## Application for Licence Amendment

<b>Licence Number</b>	L6420/1988/14
<b>Licence Holder</b>	Kalgoorlie Consolidated Gold Mines Pty Ltd
<b>ACN</b>	009 377 619
<b>File Number</b>	DER2015/002506-1
<b>Premises</b>	<p>Fimiston Processing Plant</p> <p>Tenements G26/15, G26/44-68, G26/70-71, G26/73-78, G26/82-86, G26/99-107, G26/138-145, G26/149, G26/159, G26/160, G26/165, G26/166, L26/267, M26/39, M26/46, M26/78, M26/86, M26/95, M26/267-268, M26/294, M26/308, M26/326, M26/359, M26/377, M26/383, M26/405, M26/448, M26/451 M26/715, M26/81, M26/83, M26/86, M26/266, M26/267, M26/294, M26/326, M26/373, M26/379, M26/454, M26/518, M26/748, and M26/800, KALGOORLIE WA 6430</p> <p>As defined in Schedule 1 of the licence.</p>
<b>Date of Report</b>	7 May 2024
<b>Decision</b>	Revised licence granted

**Figure 1: Groundwater monitoring bores to be decommissioned and the area where replacement bores will be constructed.**

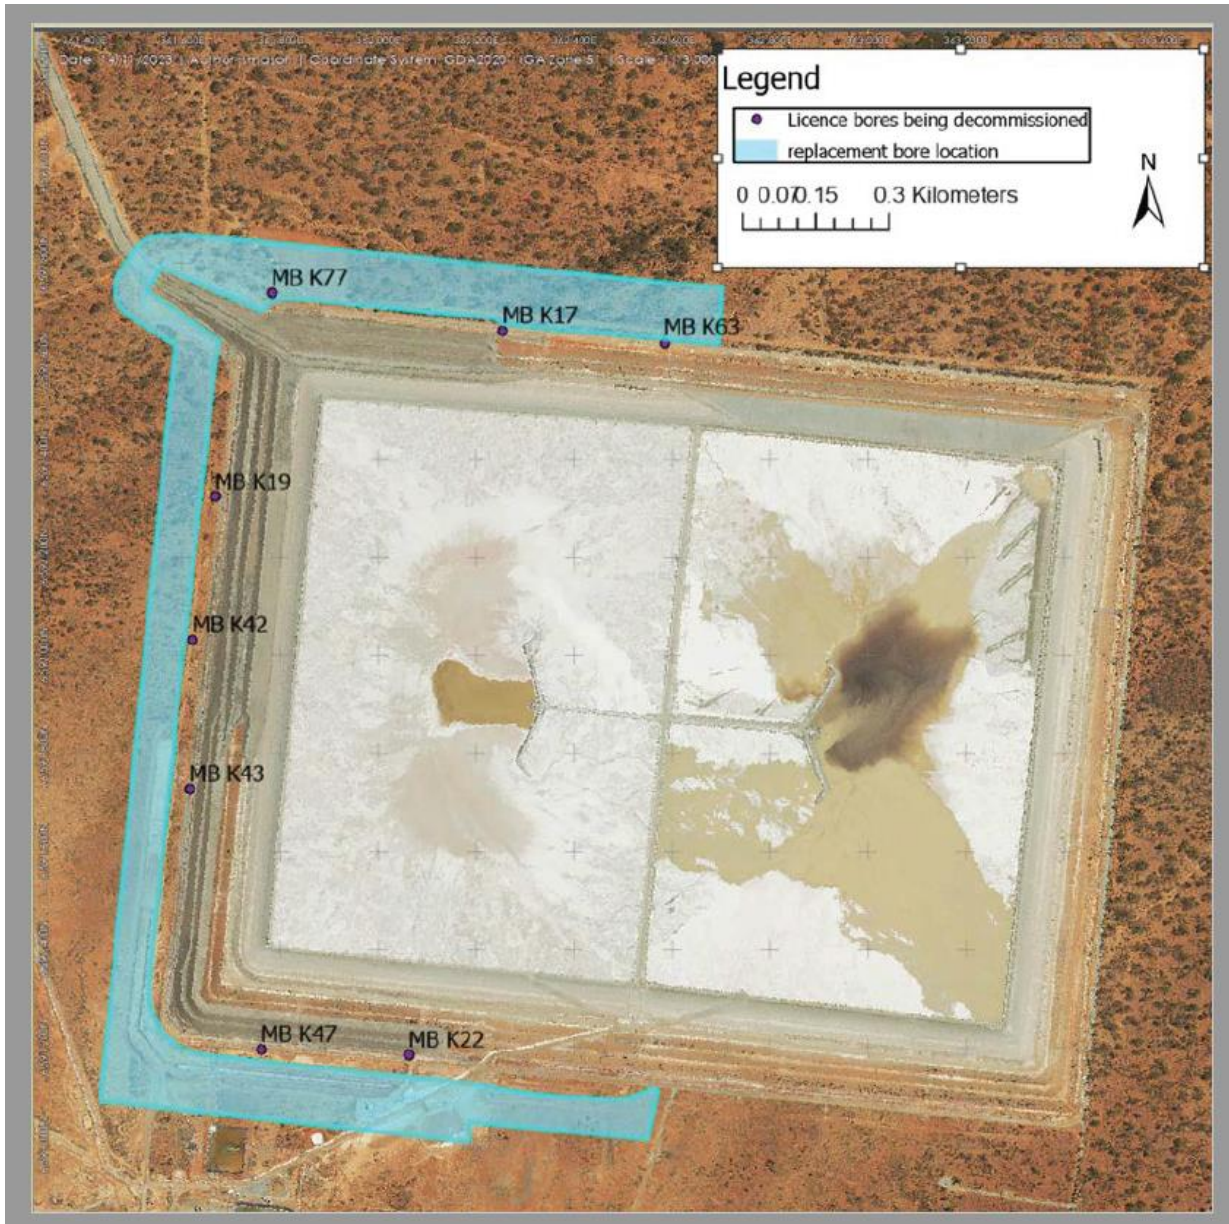
Due to the construction of the buttressing, four licenced monitoring bores will be required to be decommissioned as they are located within the buttressing footprint (monitoring bores MB K19, MB K22, MB K43, MB K47). Six new monitoring bores (MK K78, MB K79, MB K80, MB K81, MB K82, MB K83) are proposed to be constructed within the new infrastructure corridor outside of the area where any future buttressing work is planned. Due to the nature of the hydrology and lithology of the surrounding Kaltails area, the final location of the monitoring bores cannot be determined until after drilling. Therefore, the Licence Holder is requesting approval to install the bores within a specified zone as shown in Figure 1. It is proposed that replacement bores will be installed with 50 mm PVC to a depth of 24 meters below ground level (mbgl) and screened with ferricrete and alluvial sediments.

**Figure 2: Location of the buttressing work and monitoring / recovery bores that will be impacted and will need replacement.**

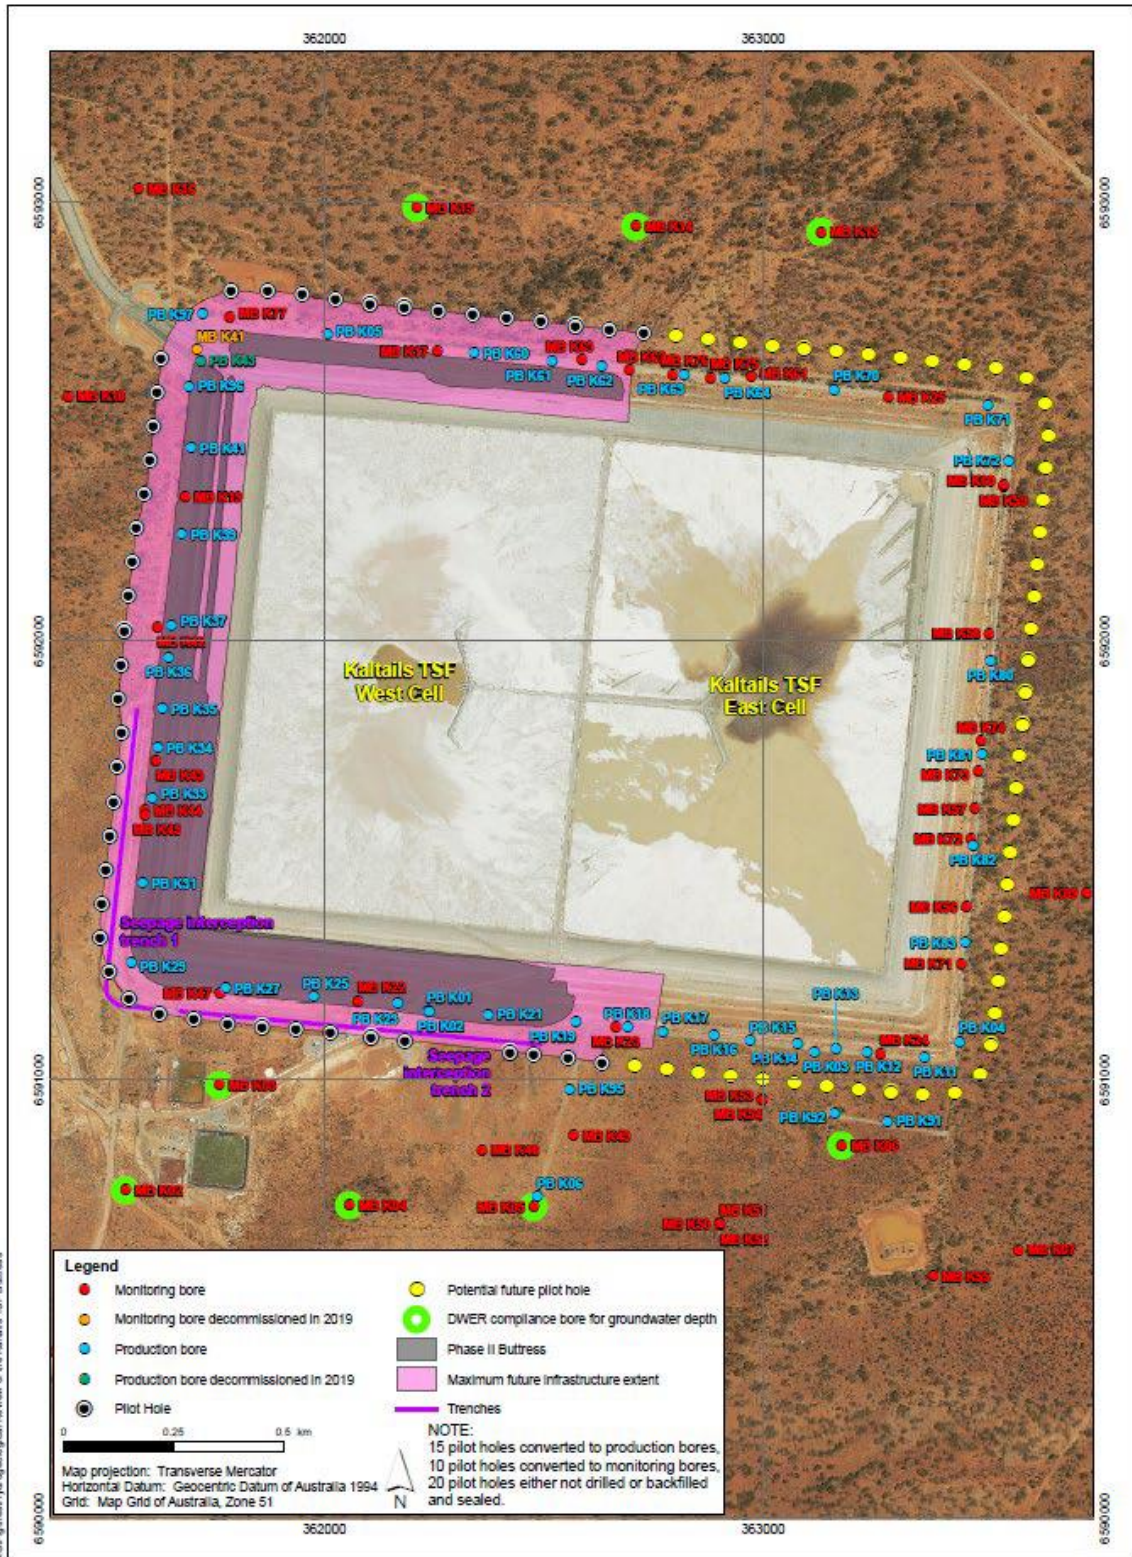
As a result of the planned buttressing work a number of production bores managed under this KSGMP (and groundwater licence GWL159860(6) issued under the *Rights in Water and Irrigation Act 1914*) will also be decommissioned, with new production bores being constructed and relocated into the new infrastructure corridor (see Figure 2). It is anticipated that 15-20 production bores will be required to be replaced. The KSGMP will be updated once the new bores have been installed.

Figure 3: Location of TRP2 and TRE bores and their replacement locations.

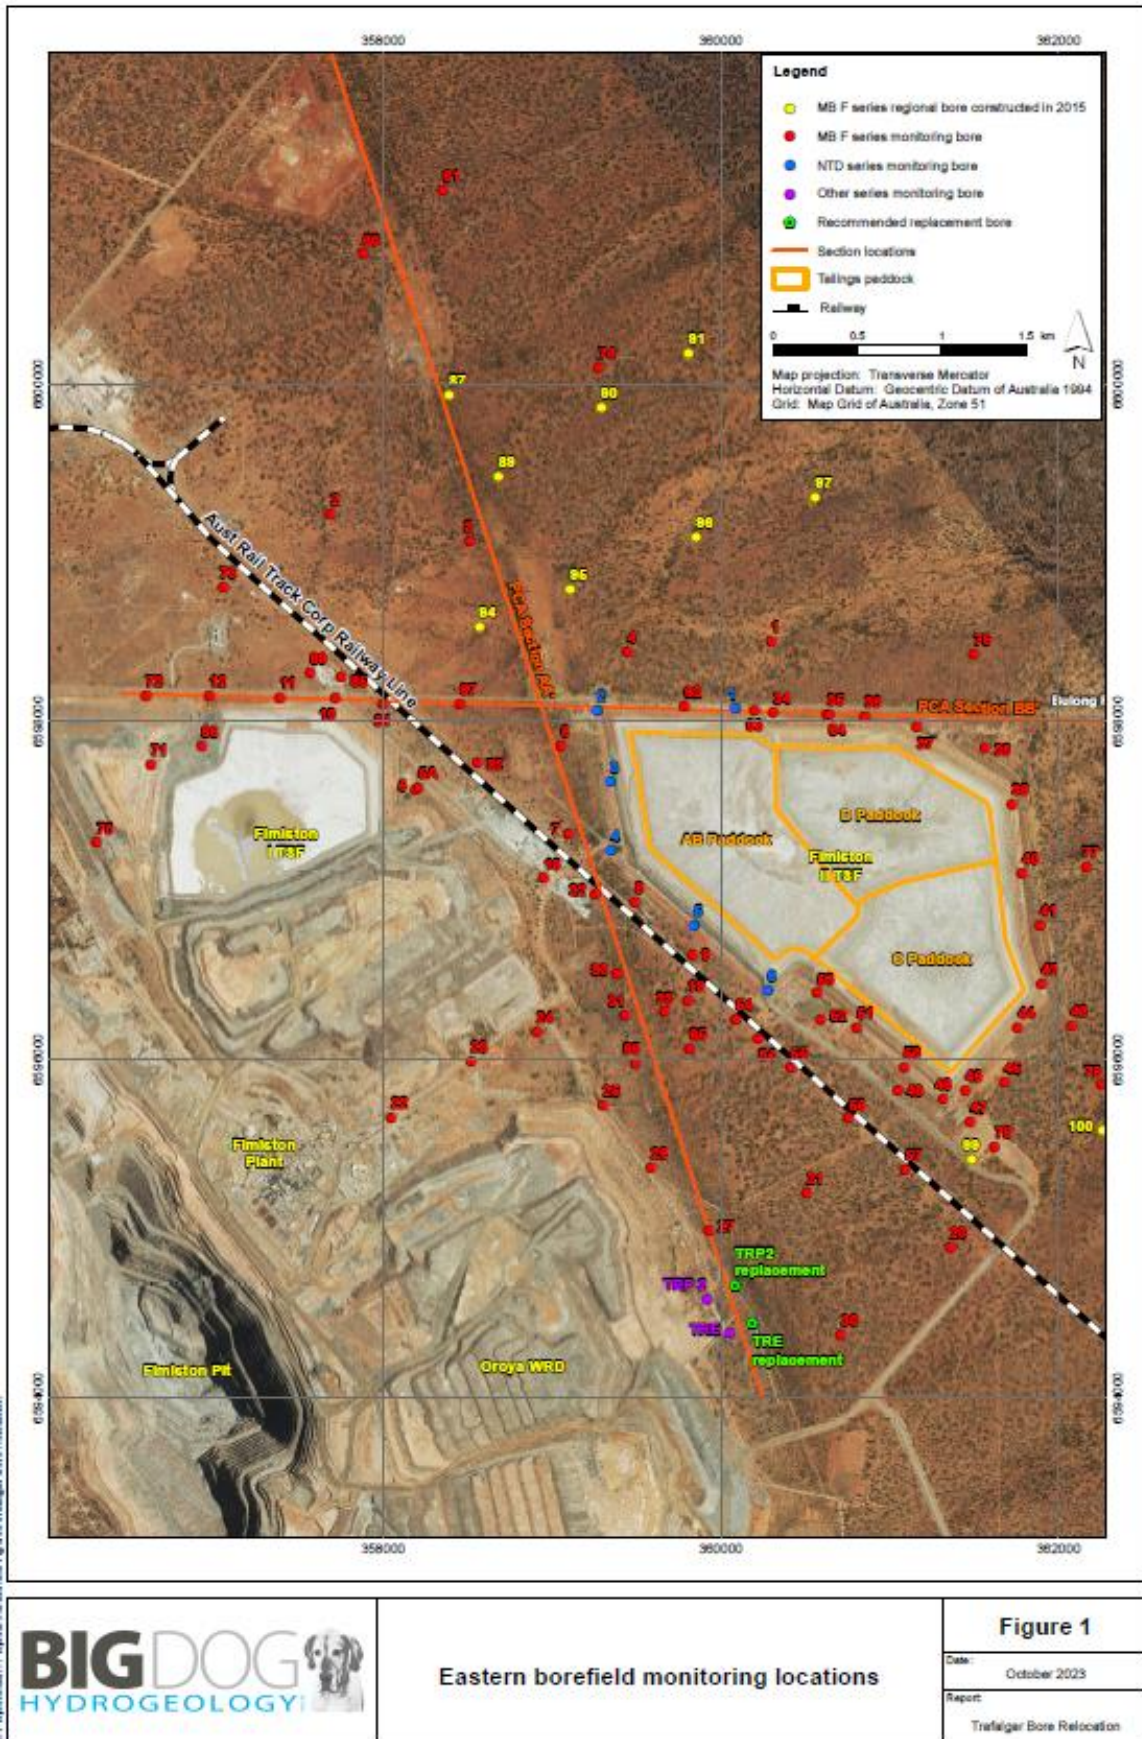
The Licence holder is planning to expand the Oroya Waste Rock Dump (WRD), which will require monitoring bores TRE and TRP2 to be decommissioned. These bores are associated with the Trafalgar Borefield and have been listed on the licence as regional monitoring bores. From 1993 to 2011, TRE and TRP2 demonstrate steadily deepening groundwater depths, which reflects the recovery of seepage influences after the Oroya TSF located to the west (and now buried by the WRD) was decommissioned sometime around 1996. From 2011 onwards, TRE and TRP2 demonstrate shallowing groundwater depths due to some degree of groundwater mounding due to the expansion of the Oroya WRD towards these bores.

Two replacement bores (TRP3 and TRP4) will be constructed outside of the WRD footprint further east of the current location. The Licence Holder engaged a consultant who undertook a hydrogeological assessment (BDH, 2023) to determine suitable new locations for these two replacement bores. The two new locations are shown in Figure 3. The rationale for selecting these locations (as outlined in BDH, 2023) was:
